**CITY COUNCIL MEETING**

**APRIL 19, 2022**

**SALE AND DEVELOPMENT  
OF  
PARCEL GROUP 5  
BUNKER HILL**

This email and its attachment includes comments from Friends of San Lorenzo Creek (FSLC) on the proposed Bunker Hill project that will be heard at the April 19 City Council meeting as item #14, PH 22-021.

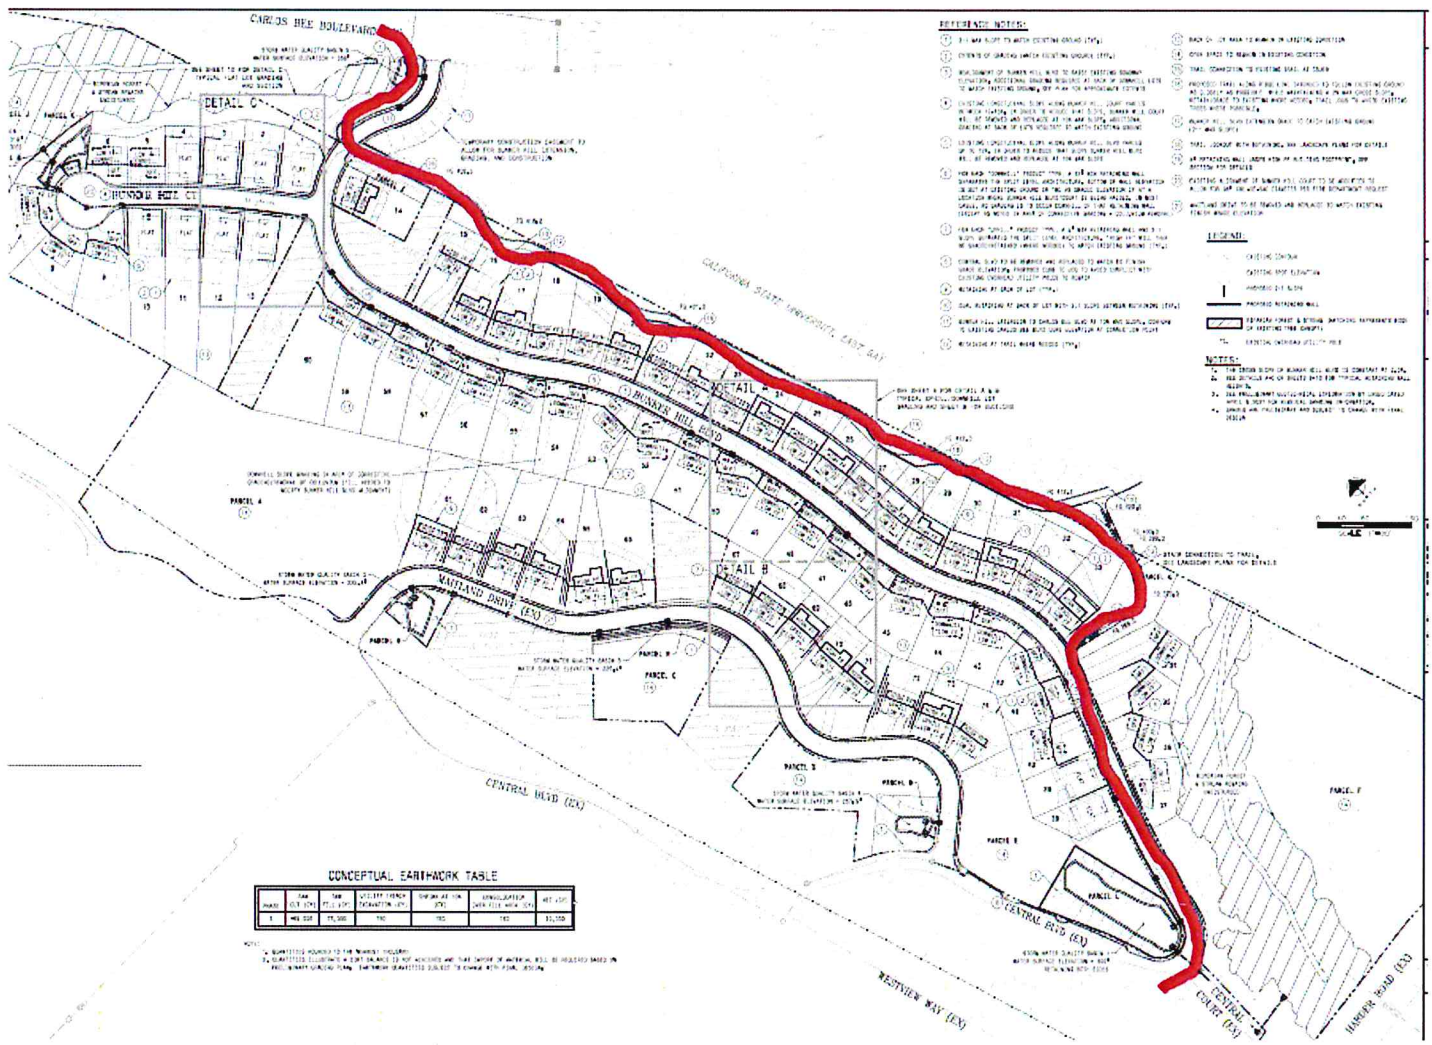
**Your Questions:** How much uphill do people have to come from the trail at Carlos Bee Boulevard on the north side. I did not make out the alignment on the south side of Bee coming up east across the Bunker Hill extension to then go south. What is the average elevation along the trail below the campus? How does the trail at Harder Road on the north side connect over to a probable alignment on the south side? I can see why the alignment has been pushed way uphill; it avoids the driveways along Bunker Hill and a steeper slope that might be possible on the west side. But is it too steep? And wouldn't the elevations work better for connections north and south?

Please see a response to your questions below. I have also attached a sheet from the Tentative Map for reference to elevations and a snip below showing the proposed trail alignment in red.

**City Response:** According to Sheet 7 of the Tentative Map: on the north side, the trail climbs approximately 25 feet in elevation from new Carlos Bee/Bunker Hill intersection to the turn out for the new trail. On the south side, the trail entrance from Bunker Hill Blvd runs on a staircases between lots 33 and 34, and there is an approximately 51 foot elevation gain from Bunker Hill Blvd to the top of the ridge trail connector. There is no trail connector to Harder Road which was determined too steep at about 35% grades. The majority of the trail is built along the ridge and follows the natural topography of the site. The trail undulates approximately 20 feet in elevation along the finished grade.
